**COUNTY OF SAN LUIS OBISPO BOARD OF SUPERVISORS
AGENDA ITEM TRANSMITTAL**

SUBJECT: HEARING TO CONSIDER AN APPEAL BY ERIK FORBES OF THE PLANNING COMMISSION'S DENIAL OF A PROJECT TO ALLOW A PARTIALLY-CONSTRUCTED, UN-PERMITTED SECONDARY RESIDENCE WITHIN THE BLACK LAKE CANYON CANYON RIM BUILDING SETBACK AREA. THE PROJECT SITE IS LOCATED AT 2138 CALLENDER ROAD, APPROXIMATELY 800 FEET EAST OF SHERIDAN ROAD, WITHIN THE CALLENDER-GARRETT VILLAGE ON THE NIPOMO MESA, IN THE SOUTH COUNTY PLANNING AREA. COD2005-00048

Forbes Secondary Residence - COD2005-00048

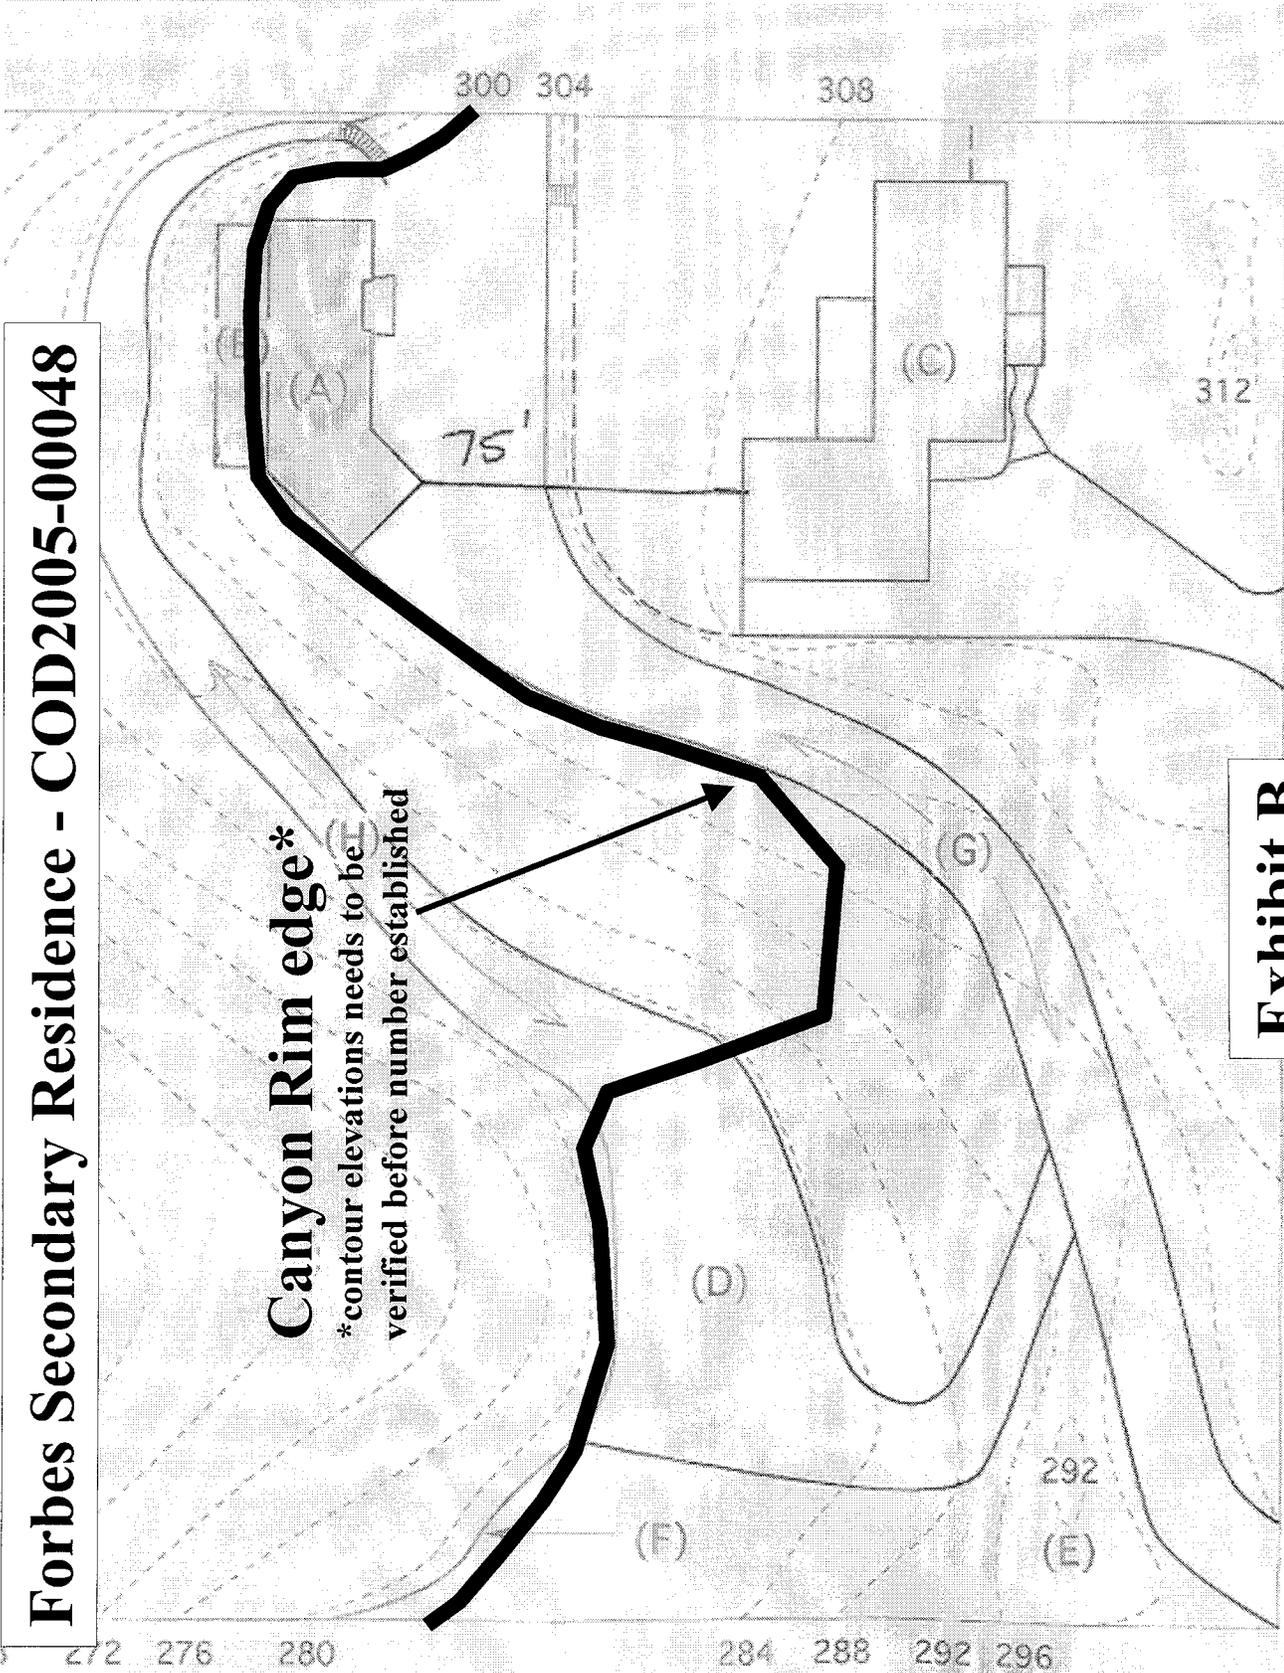
Canyon Rim edge*

*contour elevations need to be verified before number established

CROSS SECTION 1

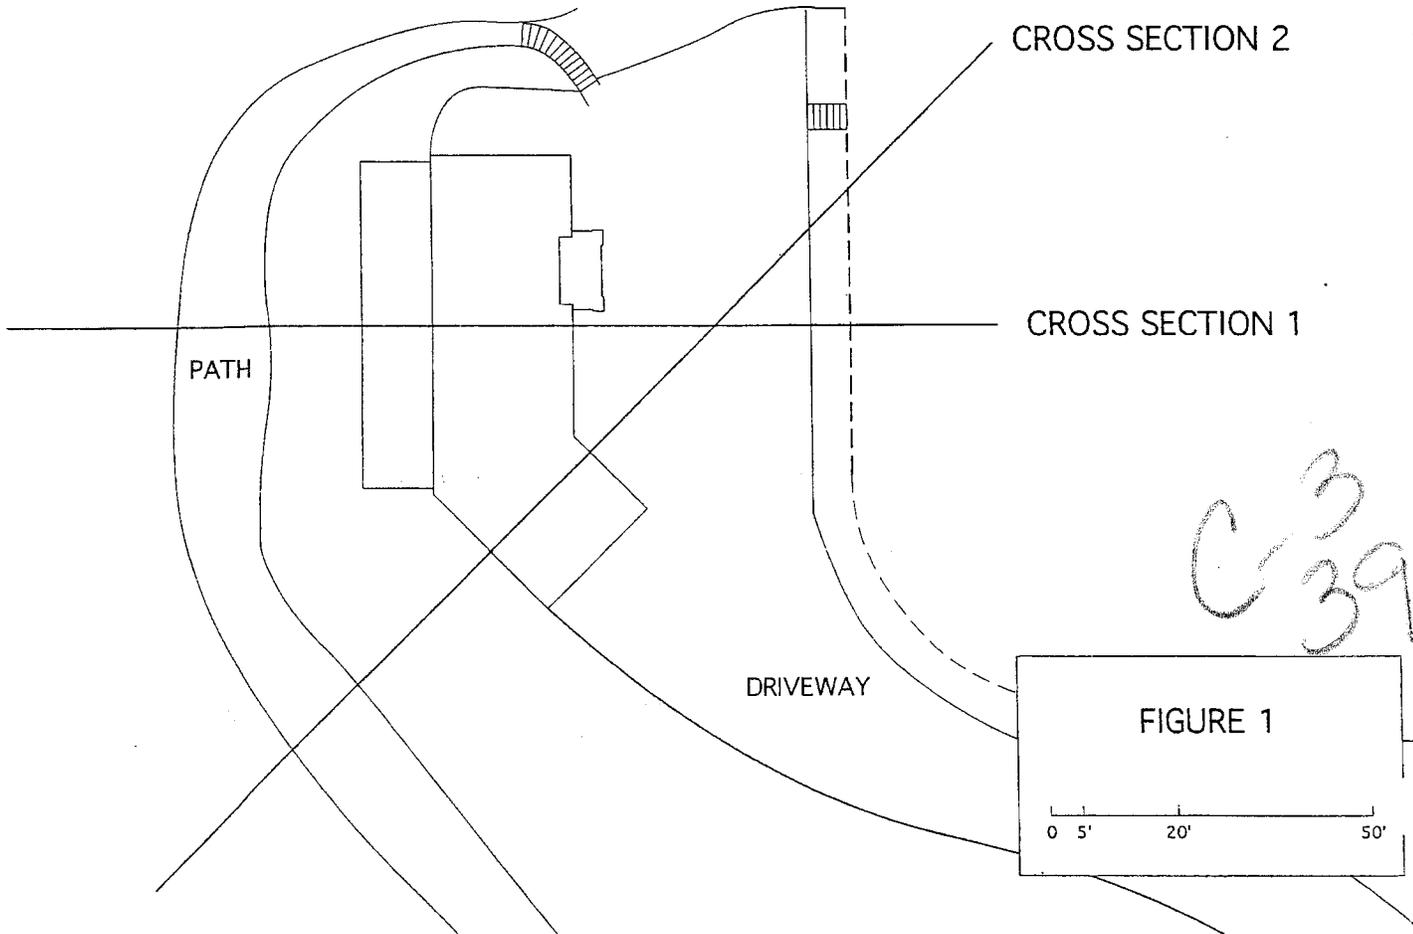
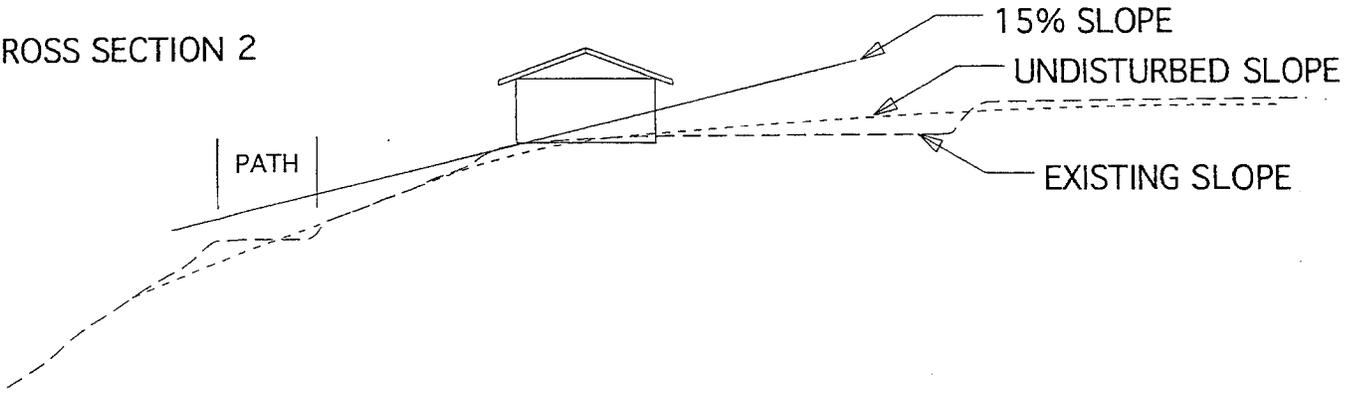
Using the depiction of the undisturbed slope in fig. 1 to help determine the rim of the canyon as is called for by the Community Planning Standards, presents some problems. The first problem is that the change in slope relative to the top of the ridge is a gradual one with no apparent physiographic clue as to where the rim of the canyon might be. The Cypress Ridge EIR discusses this same difficulty on pages V-3 thru V-5. The EIR explains that on areas of the Cypress Ridge property the forces that formed the canyon often intersected existing formations leaving no recognizable rim (See fig. 4 taken from the Cypress Ridge EIR). It seems that a similar conditions exist on the ridge in question and therefore the same problem in determining the location of a rim.

The second problem is in determining the relevance of the changes in grade made over the past 40 years to the site. Should the division of areas with "mesa influence" and "canyon influence" be made, by considering the undisturbed condition of the border or should it take into account existing conditions? Unfortunately the Community Planning Standards do not offer any guidance in answering this question. The EIR's for Cypress Ridge and the Black Lake Canyon SRA, however do, albeit in an indirect way. Both EIR's identify preservation of the marshland flora and fauna as the goal of the SRA and the condition of the canyon walls important only insofar as they help preserve the flora and fauna of the canyon, such as, by preventing erosion and providing wildlife corridors etc. In fact, the Black Lake Canyon EIR goes so far as to consider several differing methods of bordering the SRA that do not involve the rim of the canyon and recommending areas planted with eucalyptus, (such as my property) be removed from the SRA when not part of a buffer zone around marshland (pages VI-1 thru VI -12). Also, it should be noted that the forces that created the canyon are no longer at work, so there is not the necessity to return the canyon back to its natural state so that natural forces may continue undisturbed, as would be the case for other natural eco/geo systems. So, based on the practical approach taken by the EIR's mentioned, it would seem that non-natural changes made to slopes should be considered when trying to separate mesa influenced areas from those of the canyon.

EXISTING AREAS OF
< 15% SLOPE

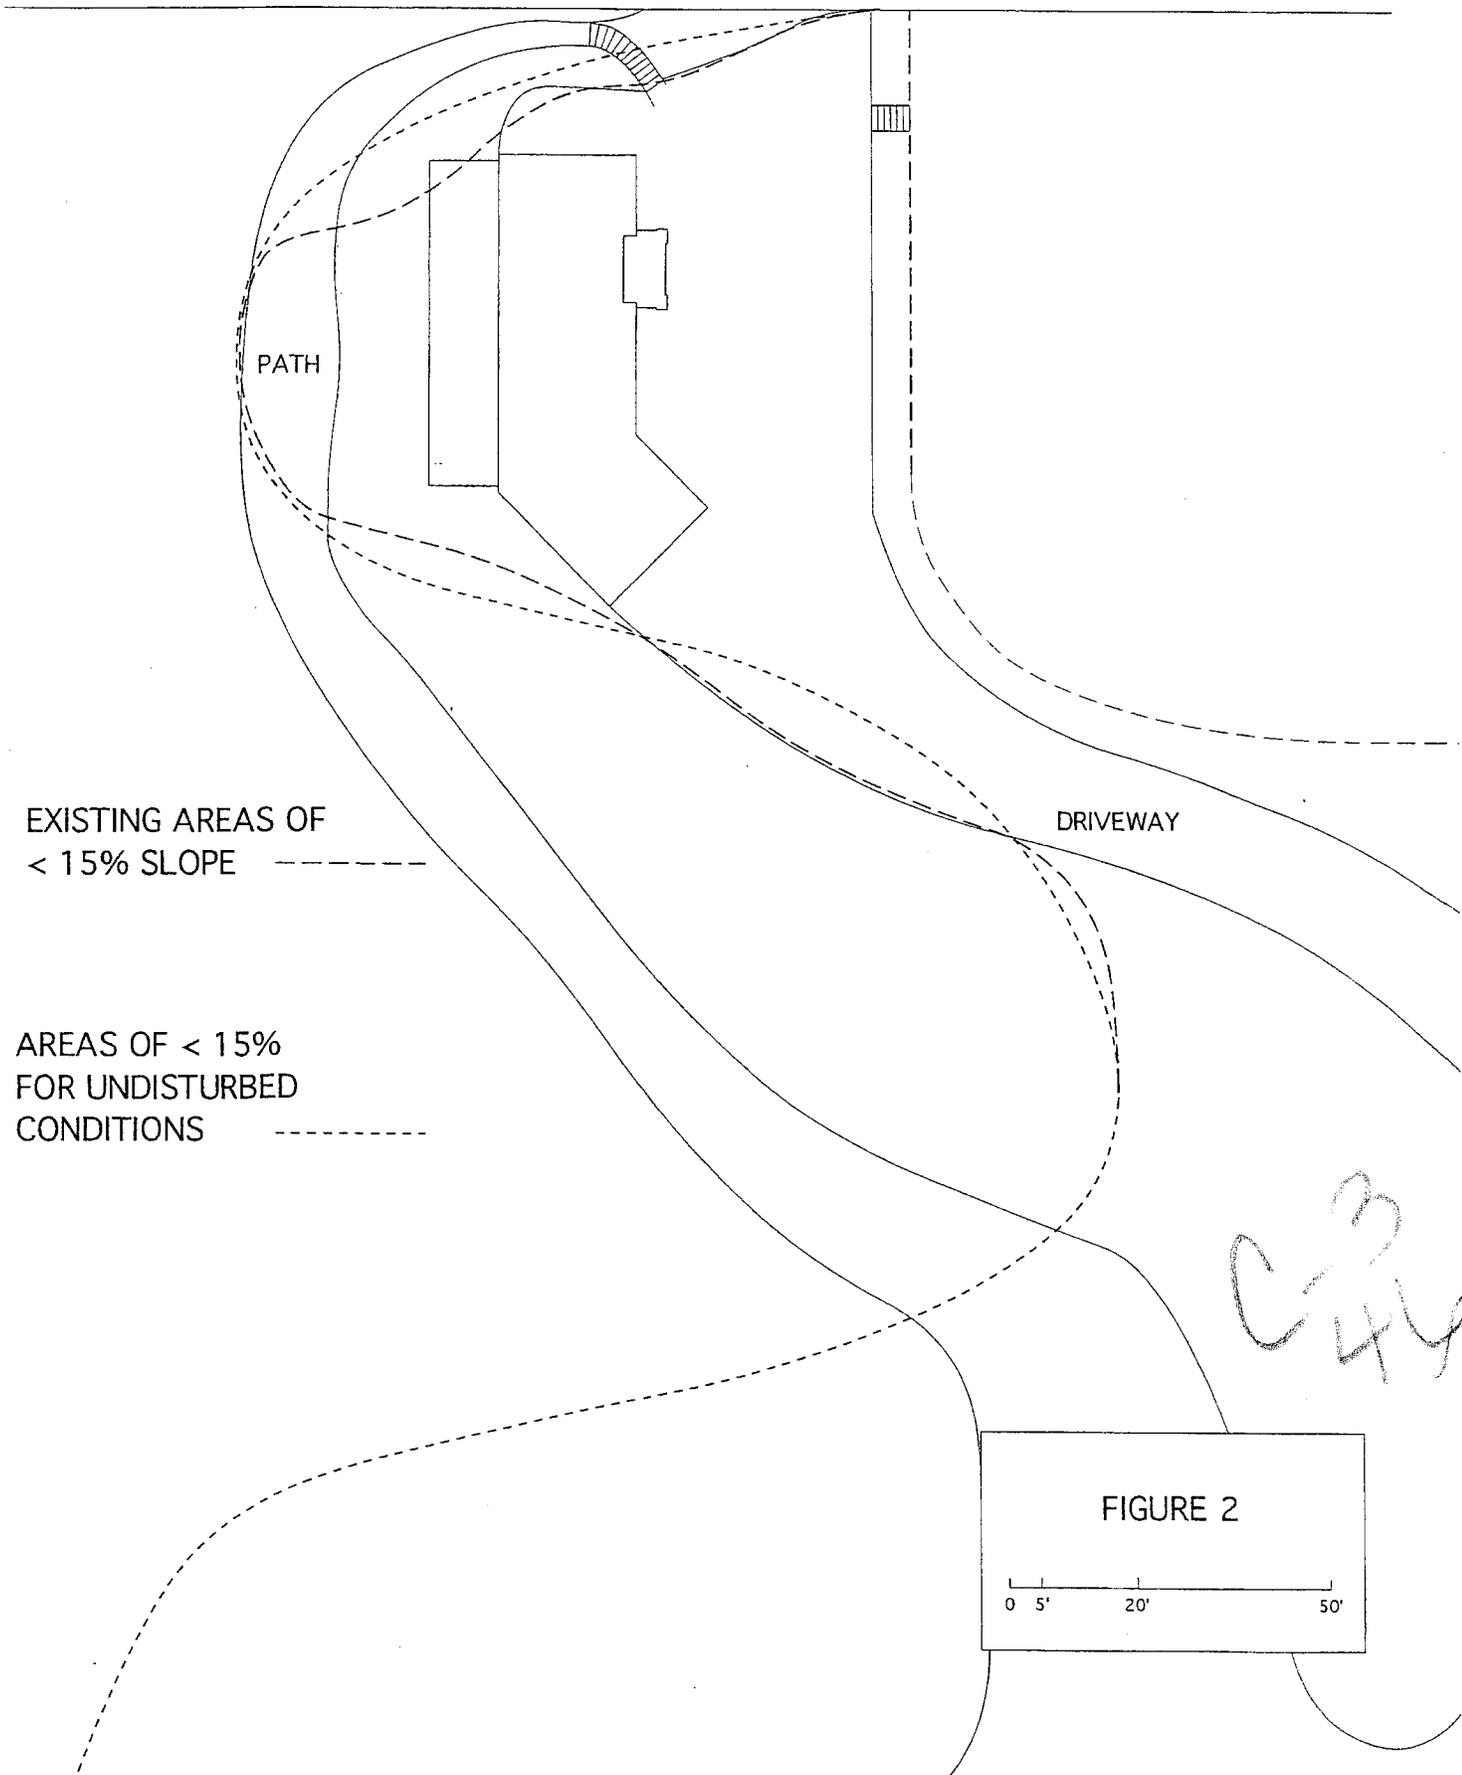
If the alternate method is used, i.e. using the edge of a 10 - 15% slope as a method for separating mesa from canyon influence, the division would appear as it does in figs. 5 and 6 for the undisturbed ridge and existing conditions respectively. In both cases the project is on the mesa side of the canyon boarder. The cantilever deck in both instances is also above the canyon boarder, the border being a question of elevation
